**PRELIMINARY DRAINAGE REPORT
FOR
FLYING HORSE NORTH PRELIMINARY PLAN
AND
FINAL DRAINAGE REPORT
FOR
FLYING HORSE NORTH FILING NO. 1**

NOVEMBER 2017

Add PCD File No. SP-17-012 and
SF-18-001

Detention Basin Outlet Structure Design

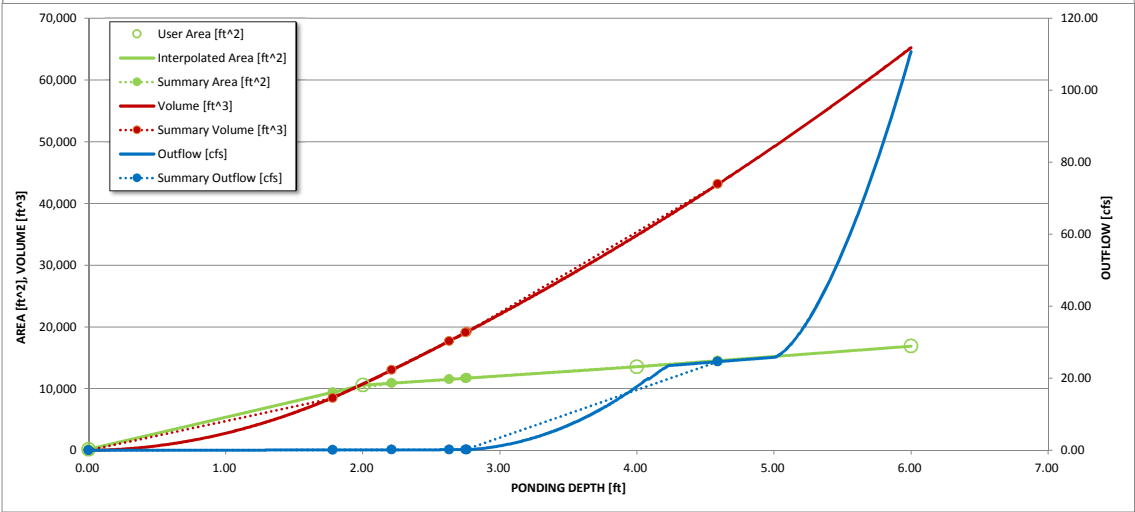
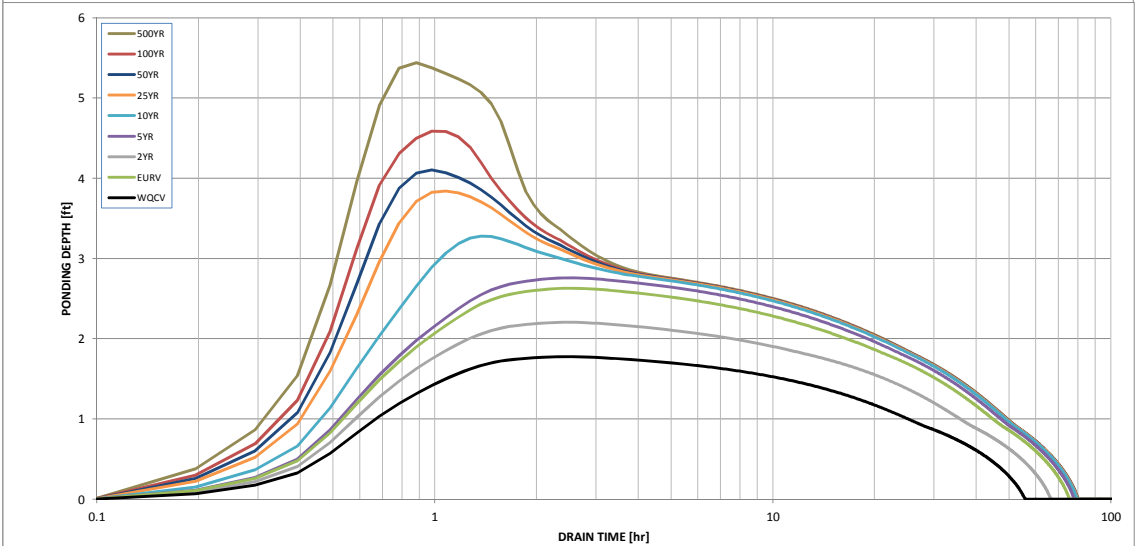
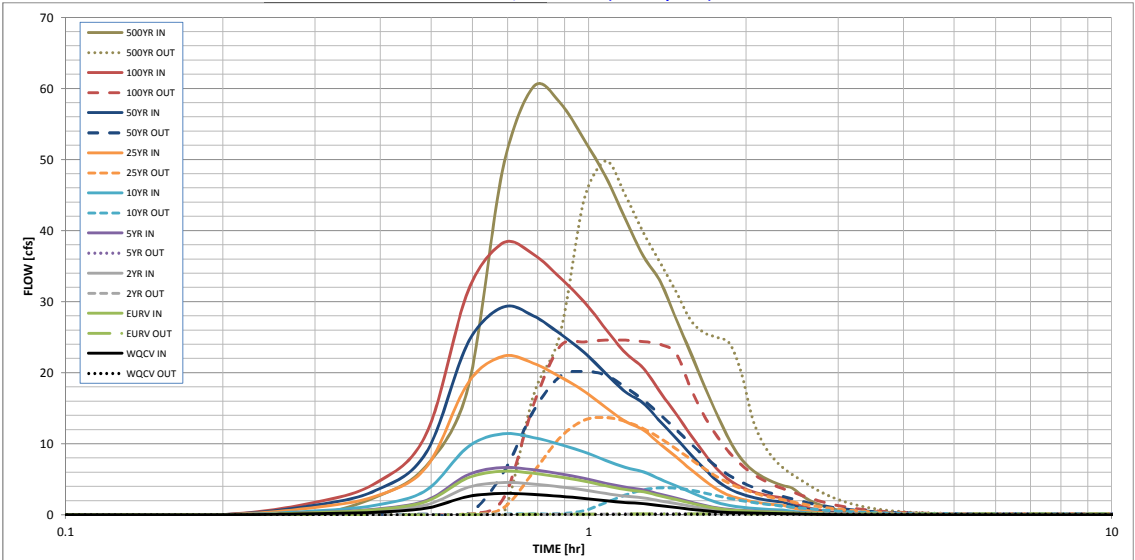
0.9 for full spectrum detention.
Comment applies for all Full Spectrum Pond design

FLYING HORSE NORTH
PRELIMINARY/FINAL DRAINAGE REPORT
FILING NO. 1 DRAINAGE MAP

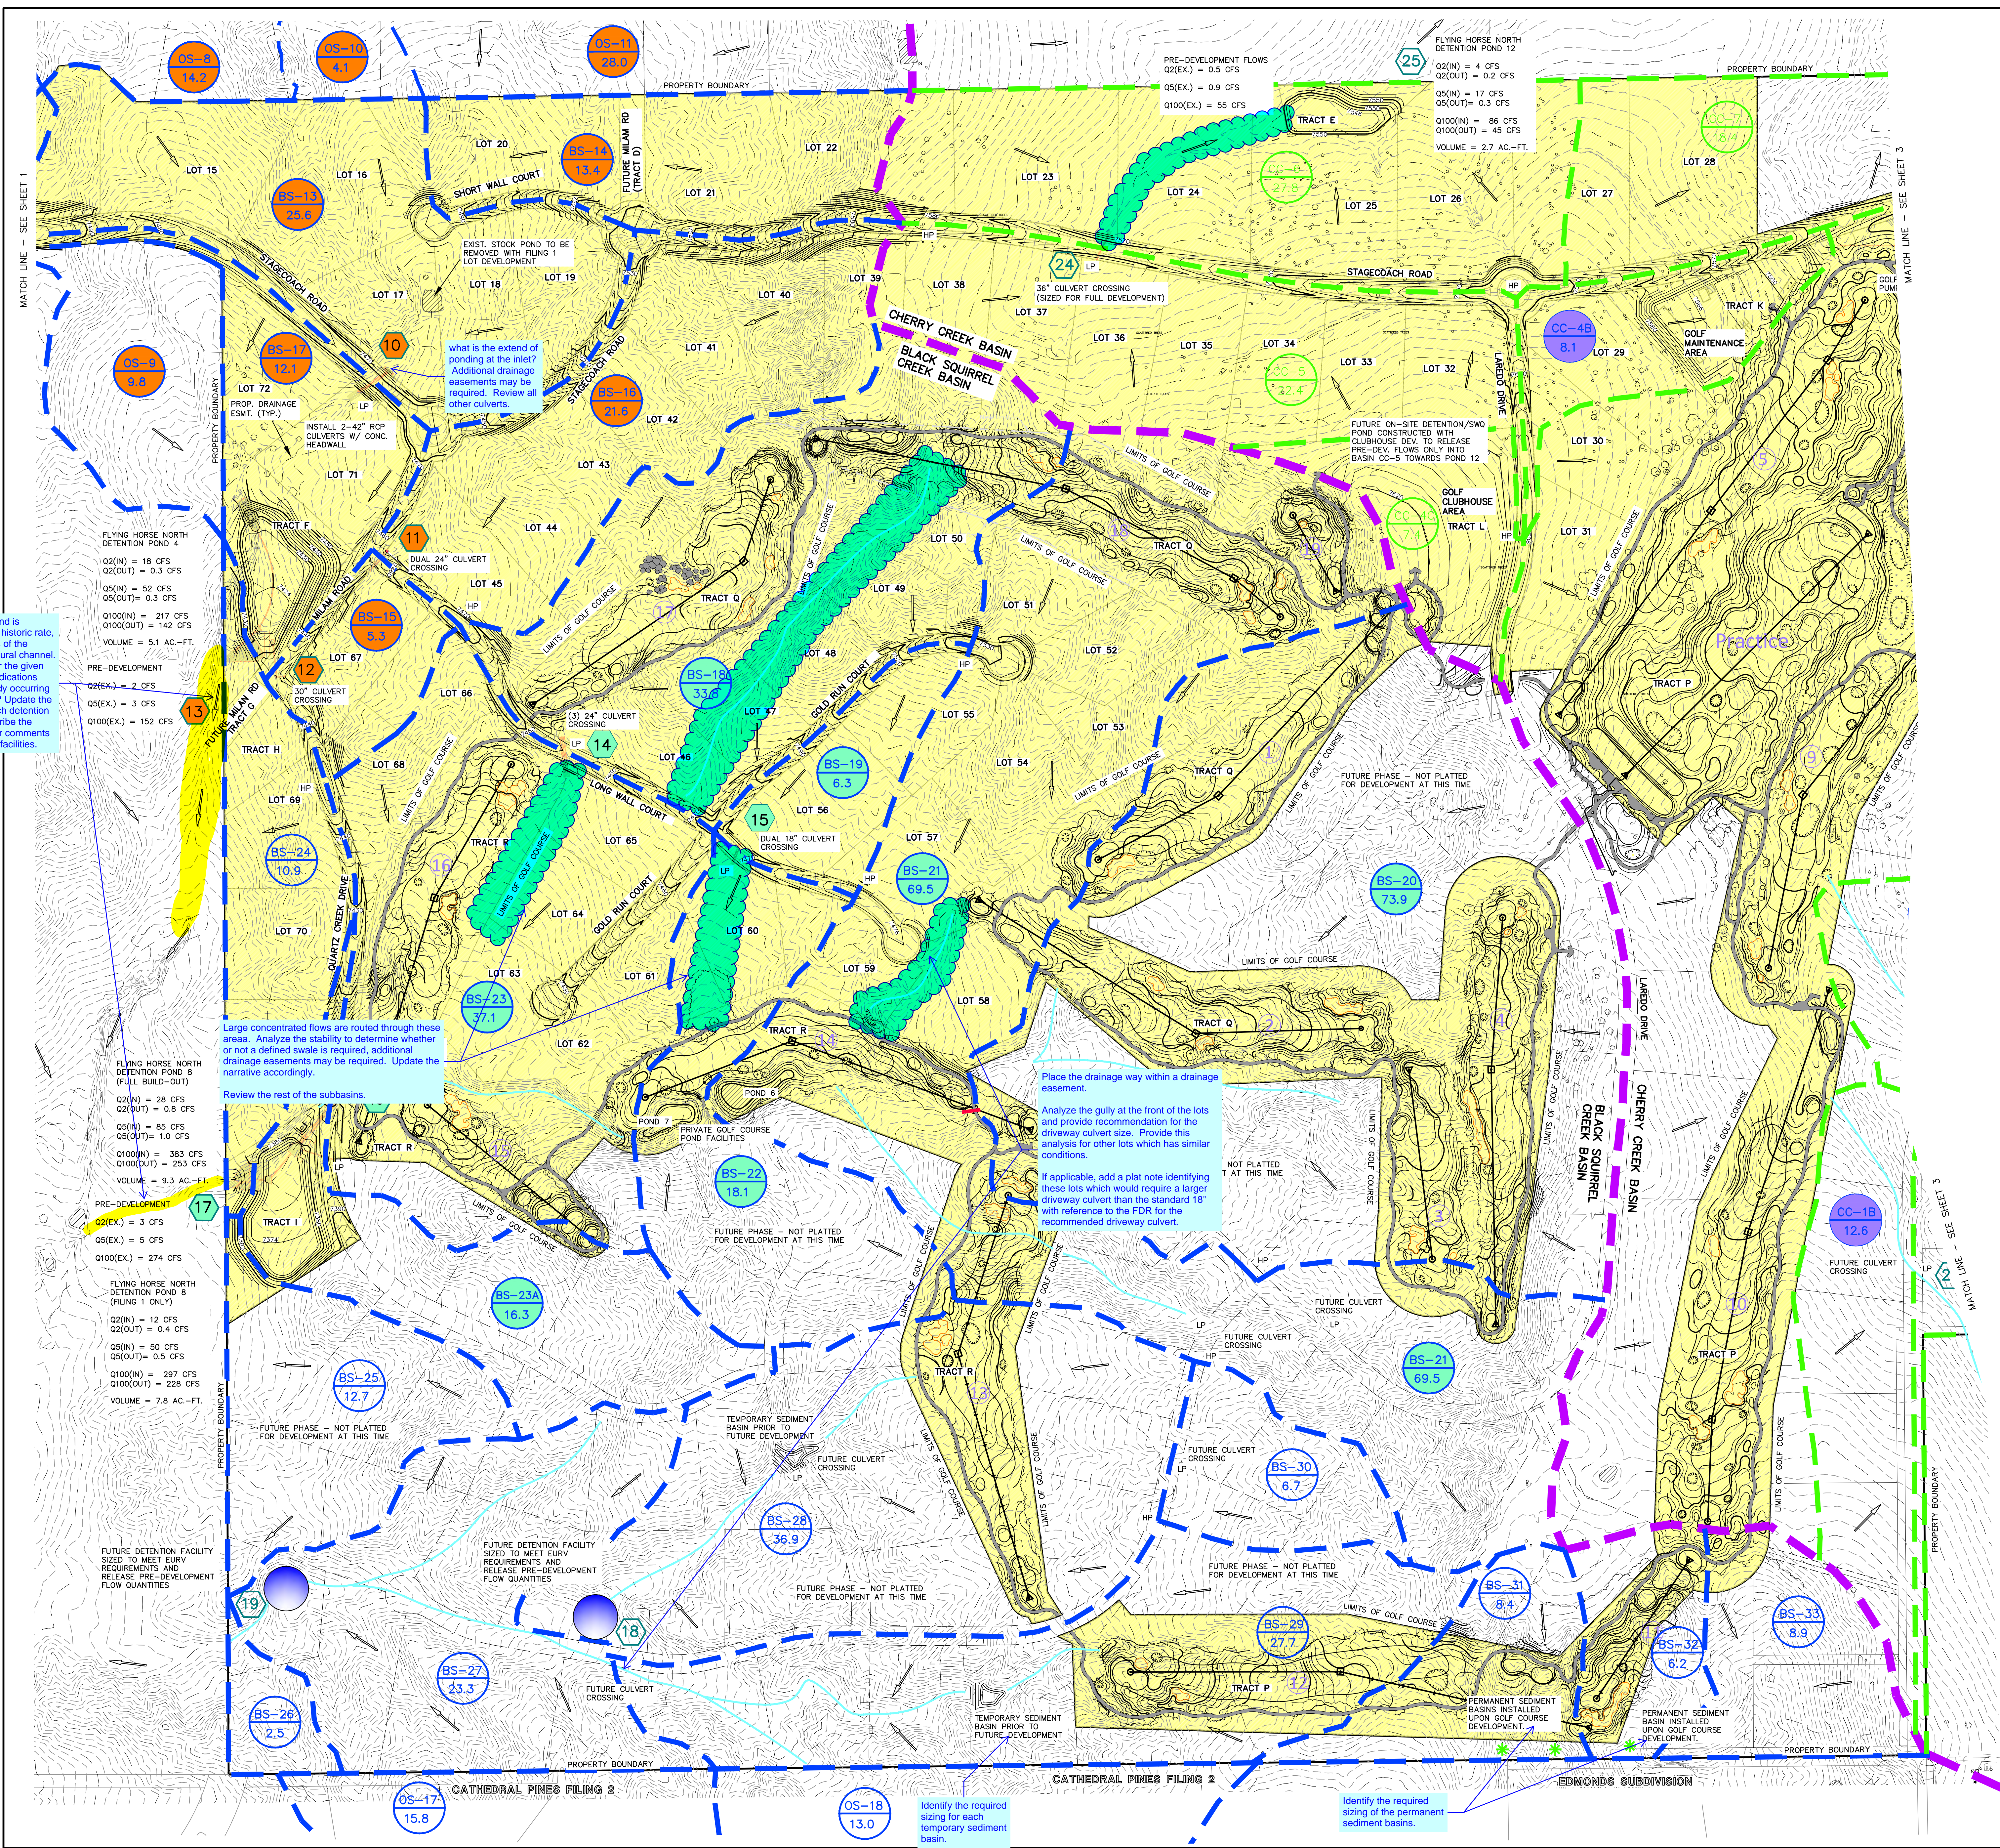
Review all other culvert locations regarding the above comment.

Show the 100yr spread from DP3. Is the natural swale sufficient to keep the runoff from draining into Pond 1?
